# PIC32MZ EMBEDDED CONNECTIVITY (EC)

## PIC32MZ Embedded Connectivity (EC) Family Silicon Errata and Data Sheet Clarification

The PIC32MZ Embedded Connectivity (EC) family devices that you have received conform functionally to the current Device Data Sheet (DS60001191C), except for the anomalies described in this document.

**FIGURE 8-1: PIC32MZ EC FAMILY OSCILLATOR BLOCK DIAGRAM**

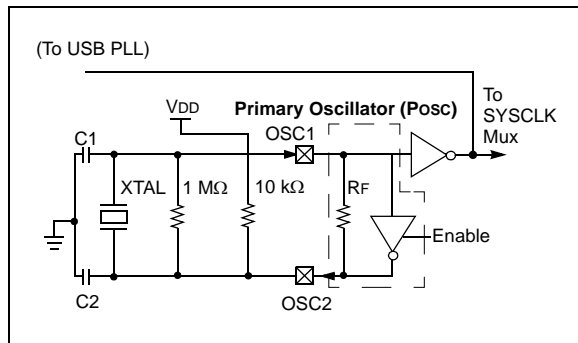
The Primary Oscillator logic in **Figure 8-1: "PIC32MZ EC Family Oscillator Block Diagram"** of the current device data sheet omitted a pull-up resistor (RK), which is necessary to ensure stable start-up of the Primary Oscillator when it is running from a crystal. This resistor must be 10 kΩ and connected between OSC2 and VDD.

The following figure shows the amended portion of the diagram.

Crystals with a speed of 4 MHz to 12 MHz that meet the following requirements will meet the PIC32MZ oscillation requirements when configured as depicted in [Figure 8-1](#).
